World Forum for Harmonization of Vehicle Regulations**Working Party on General Safety Provisions****127th session**

Amendments to Regulations on Gas-Fuelled Vehicles:**UN Regulation No. 110 (Compressed Natural Gas and Liquefied Natural Gas vehicles)****Proposal for Supplement 3 to the 03 series of Amendments to
UN Regulation No. 110 (Compressed Natural Gas and
Liquefied Natural Gas vehicles)****Submitted by the expert from the European Association of Automotive
Suppliers ***

Example 2

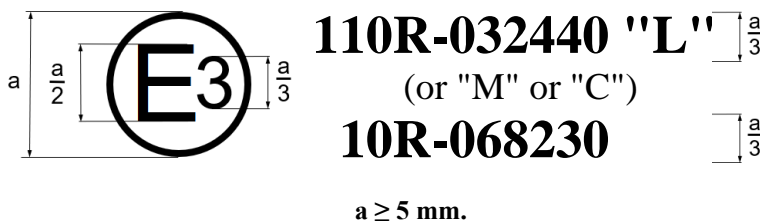
Insert new paragraph 7.4.3., to read:

"7.4.3. If the component conforms to a component type approved under one or more other UN Regulations, and if the country which has granted the different approvals is the same, the symbol prescribed in paragraph 7.4.1. above need not be repeated for that specific country; in such a case, the Regulation and approval numbers and the additional symbols of all the Regulations under which approval has been granted by the same country shall be placed in rows to the right of the symbol prescribed in paragraph 7.4.1. above."

(See paragraph 7.4.3. of this Regulation)

This approval mark when affixed to the CNG and or LNG component shows that this component has been approved in Italy (E 3), pursuant to UN Regulation No. 110 under approval number 032440 and pursuant to UN Regulation No. 10 under approval number 068230. The first two digits of the first approval number indicate that the approval was granted in accordance with the requirements of UN Regulation No. 110 as amended by the 03 series of amendments.

The first two digits of the second approval number indicate that the approval was granted in accordance with the requirements of UN Regulation No. 10 as amended by the 06 series of amendments.
